主旨: Fw: S. 16 Planning Application No. A/YL-KTN/1252 - Departmental Comments
附件: (3)LD-L1198A1-APP01.pdf; (3)S.16-III_通架場_KTN1252.pdf; (3)回應意見
(30June2026).pdf; (3)行車路線圖_KTN1252.pdf

S. 16 Planning Application No. A/YL-KTN/1252 - Departmental Comments

Temporary Open Storage of Metal Scaffolding

in DD109, Kam Tin North, Yuen Long, N.T.

行車路線圖 →

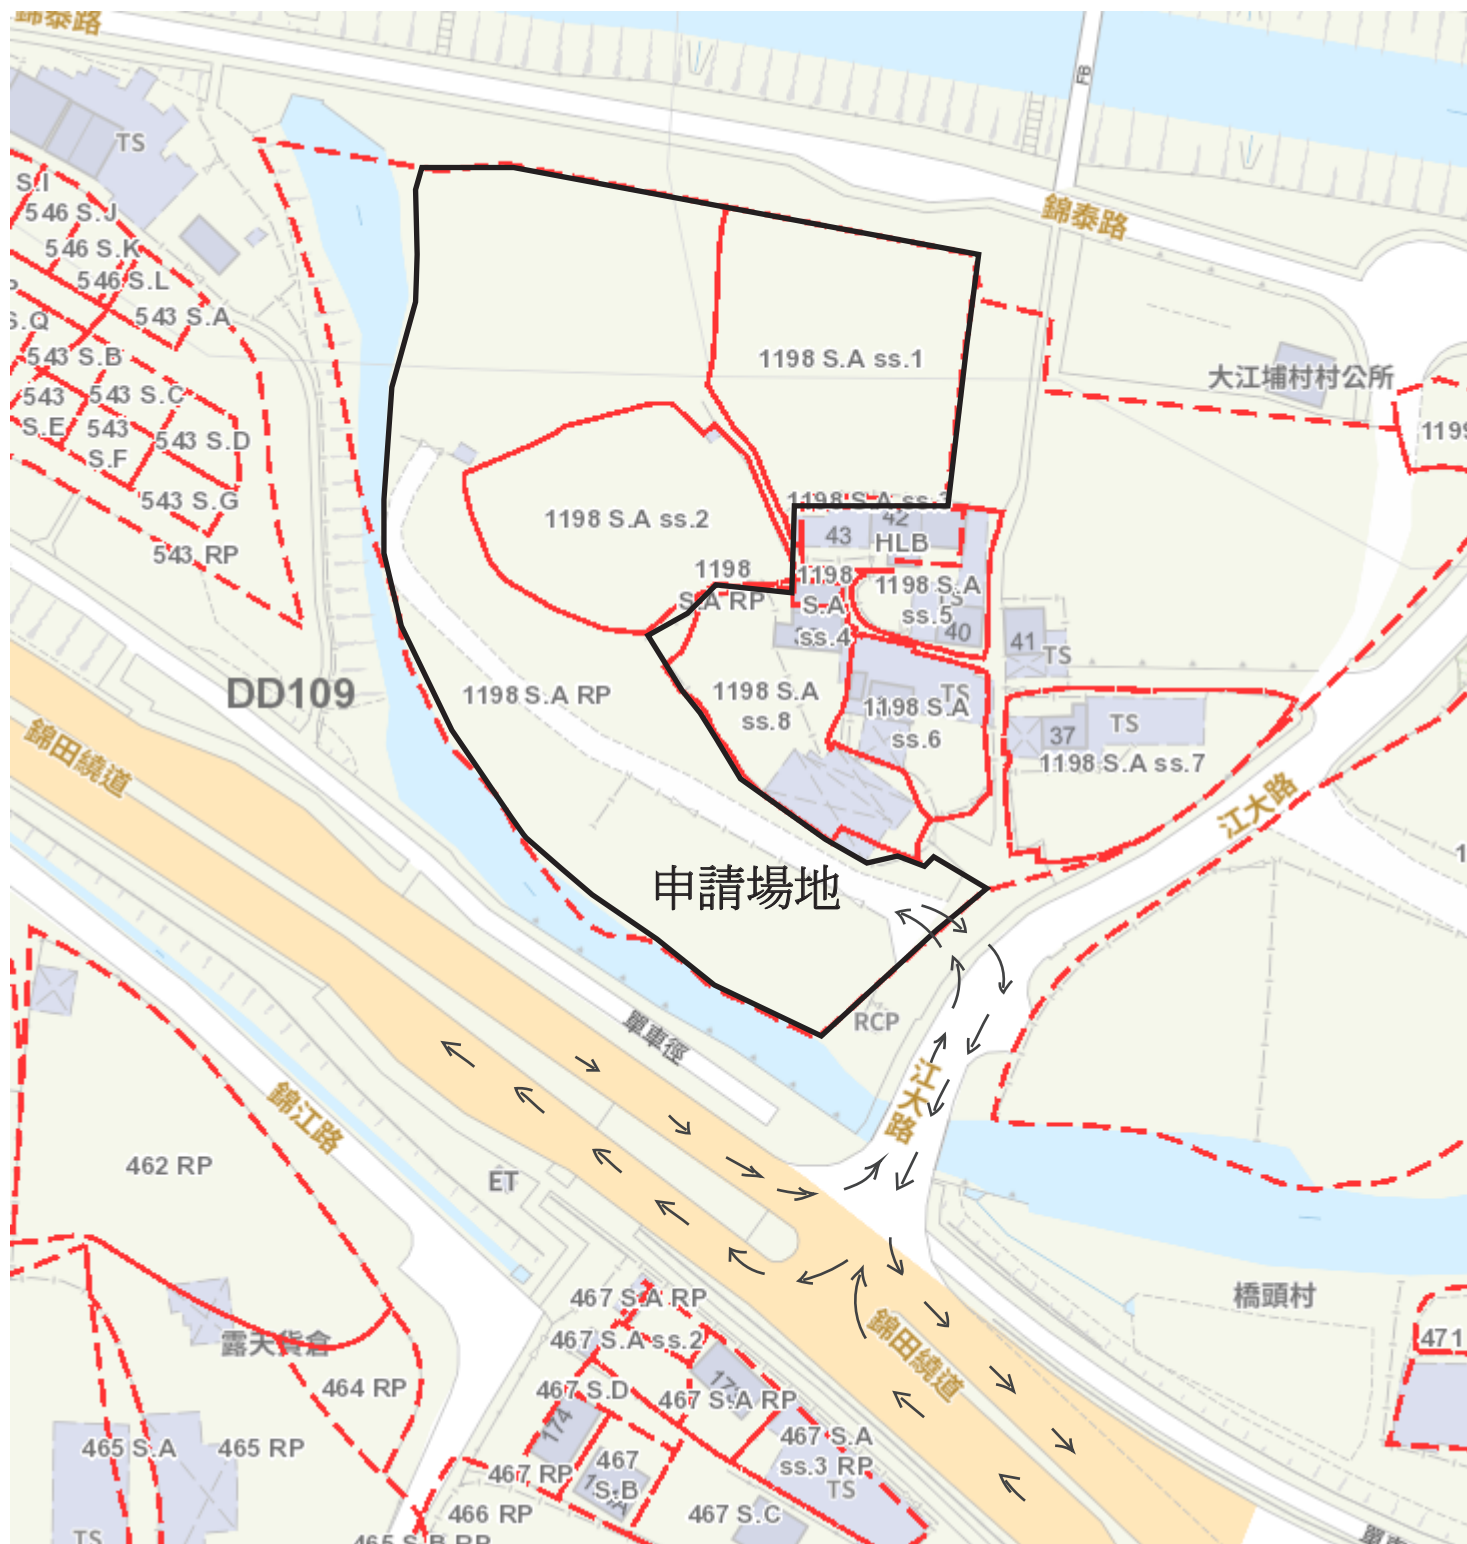
- please indicate the proposed route of the vehicular access from/to the nearby roads.

there is another ongoing application submitted by the same applicant (No. A/YL-KTN/1250) for shop and services use. Please advise if these sites are connected, despite different ingress/egress points are proposed	A/YL-KTN/1250的申請是擬建商舖及服務設施，這兩個場地並不相連，預備用圍牆分隔開，因為 A/YL-KTN/1250申請場地主要性質是用作金屬棚架臨時搭建示範，在予第三方化驗室簽發安全使用証明後會全部拆除，該場地與毗鄰的地塊分開成為獨立場地及獨立入口處，是此場地免受場內搬運而影響搭建或拆除工作是執行展示服務用途後。 此場地是與 A/YL-KTN/1250申請場地的使用性質不相同，固需以範圍上分開，明確地指出分別。
please indicate the proposed route of the vehicular access from/to the nearby roads.	<i>附件(行車路線圖)</i>
